Burst Terminator Implementation

Frank Effenberger
Huawei Technologies

Figure 92-15—SyncTime Detail

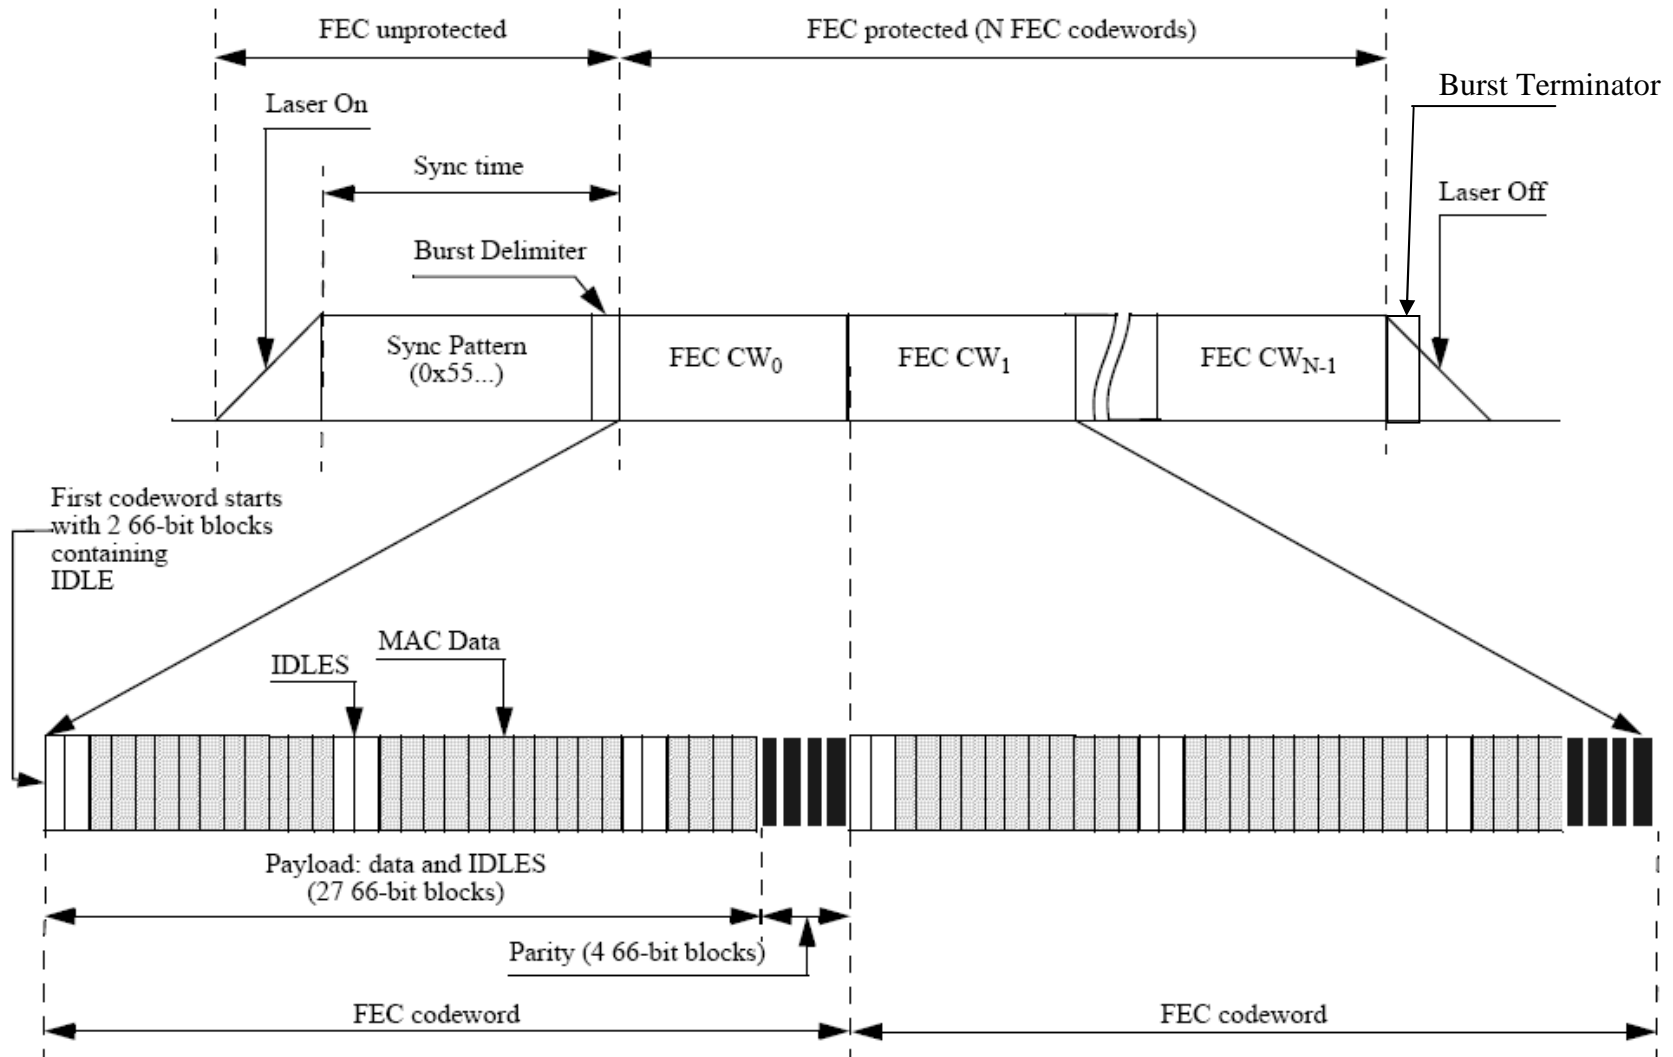
Revise Fig. 92-15

Modify Fig. 92-16

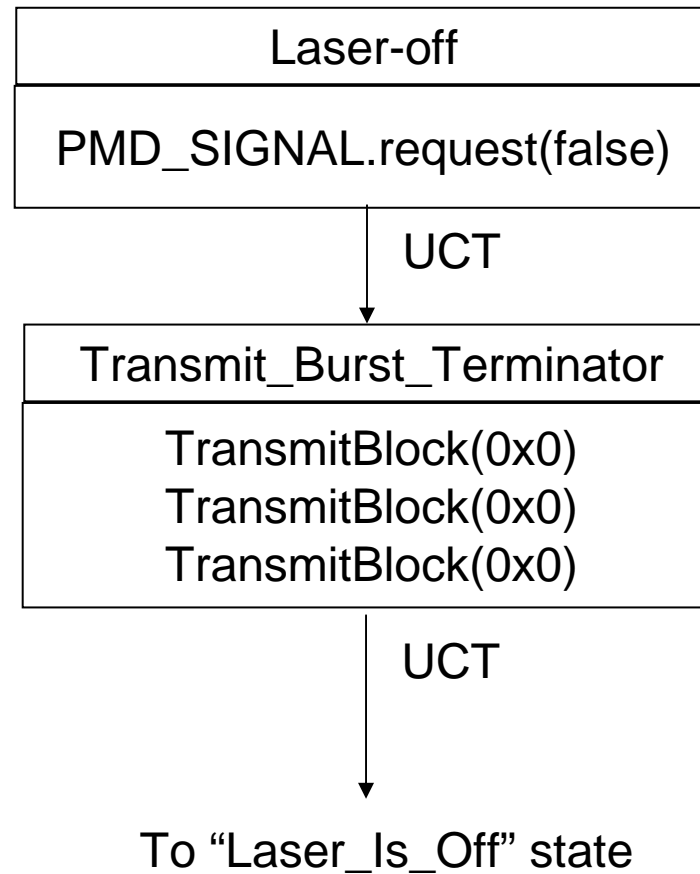
Add "Transmit burst terminator" state below "Laser off" state, as shown:
